Staff Report to the Plan Commission

Estates at Ravinia Meadows by Pulte

Project: 2024-0676 – Estates at Ravinia Meadows – Planned Unit Development

Estates at Ravinia Meadows – Site Plan

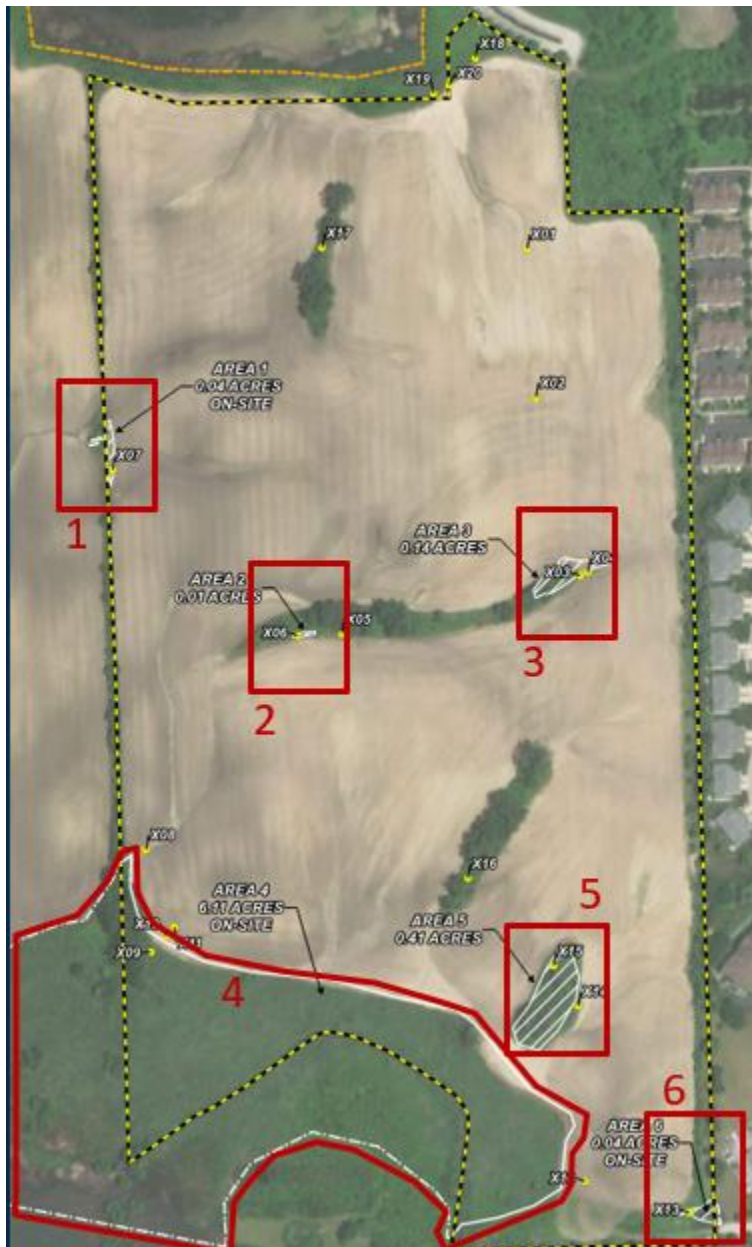
The site plan indicated 132 dwelling units, and six outlots (A,B,C,D,E & F). Outlots A and B are located along Ravinia Avenue; Outlot C is an approx. 4-acre common open space in the middle of the development; Outlot D contains the Stormwater Management Facility (SMF) for the southern portion of the site. The petitioner will construct a playground on Outlot F that will be maintained by the Village.

Outlot B will house a monument sign for the development, and petitioner intends to install fences along the southern borders of Outlots A and B.

The stormwater in southern portion of the project site is managed with three detention ponds on Outlot D, with a storage volume of approx. 71 Ac.-Ft. The Costco stormwater management facility to the north of the site provides an additional storage volume of 20 Ac.-Ft.

The on-site detention areas, along with the surrounding retaining walls to be maintained by the HOA. All the outlots, with the exception of Outlot F (with the playground), shall be maintained by the HOA.

The project site is accessible from Ravinia Avenue in the north, and from 165th street on the south. The main loop road and connections will be dedicated right-of-way roads. The overall road layout employs traffic-calming measures to prevent cars from speeding through the neighborhood, and from becoming a "short-cut" thoroughfare between 159th and 165th Streets. Along Ravinia Avenue, the petitioner will improve the road surface, median landscaping and existing sidewalk
